20-AMEND-0005

Signature Point

Louisville Metro Development Review Committee

Requests

Fencing Exhibit

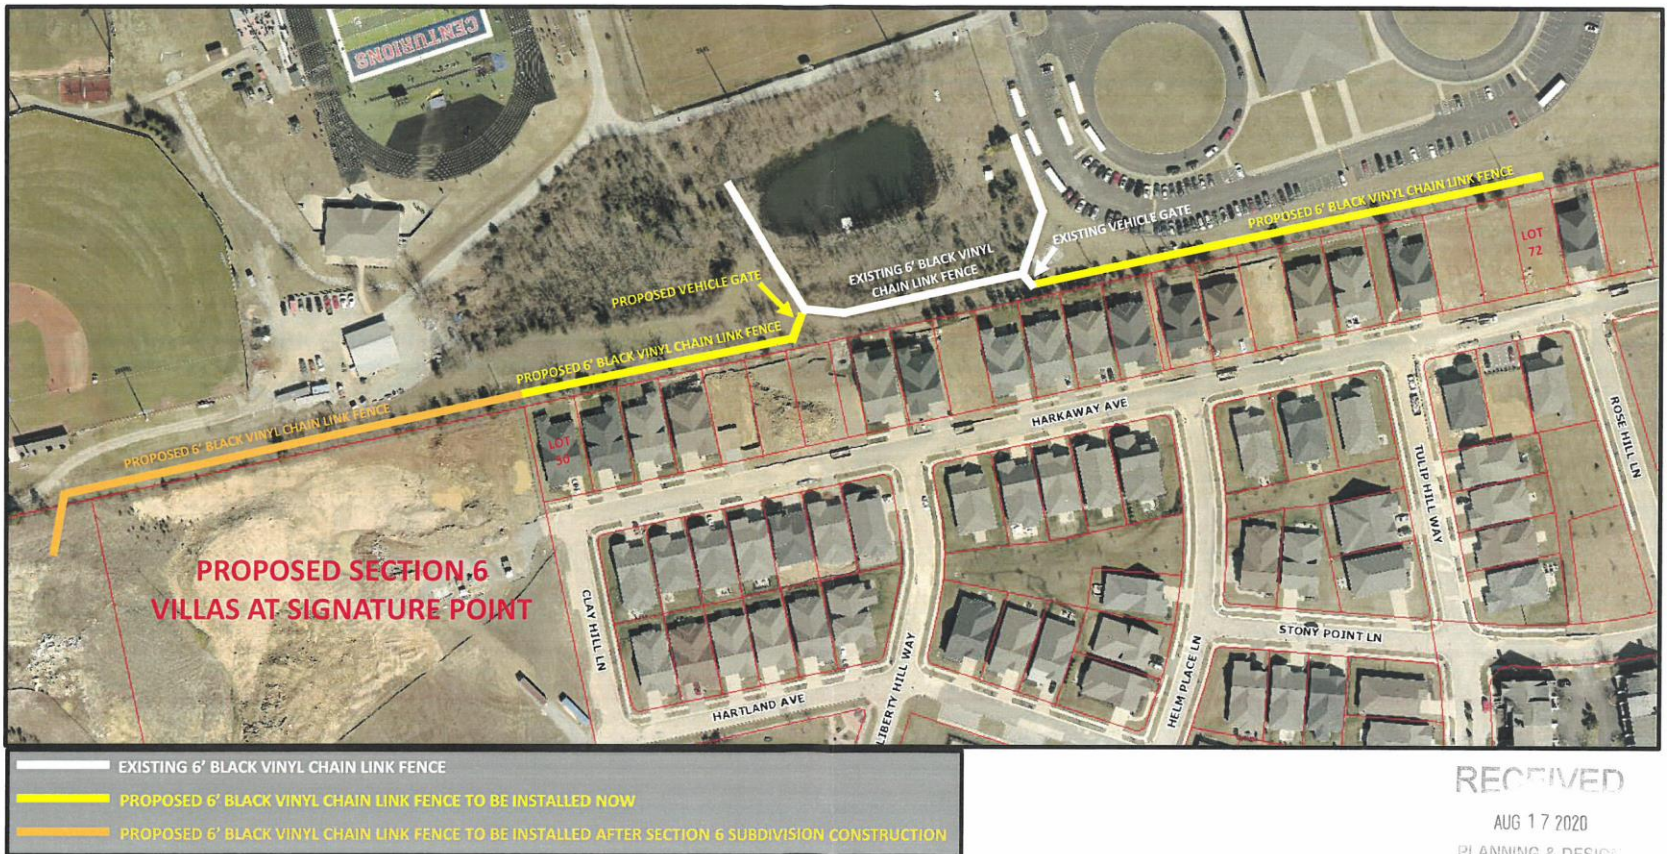
~~16. The developer shall, at its expense, construct a 7-foot chain link fence with black vinyl coating with a variety of deciduous and evergreen trees planted along this fence line on 10-foot centers along the entire property line common to Christian Academy of Louisville property. The fence shall be constructed at the earliest of the following times: (A) before construction begins on the buildings along the north line of the subject property; or (B) one year after site work begins anywhere on the subject property. The fence shall be perpetually maintained by the developer or its successor (Condominium Council, Homeowner Association, etc.).~~

The developer shall, at its expense, construct a 6-foot chain link fence with black vinyl coating as shown on the fencing exhibit presented at the September 16, 2020 Development Review Committee meeting.
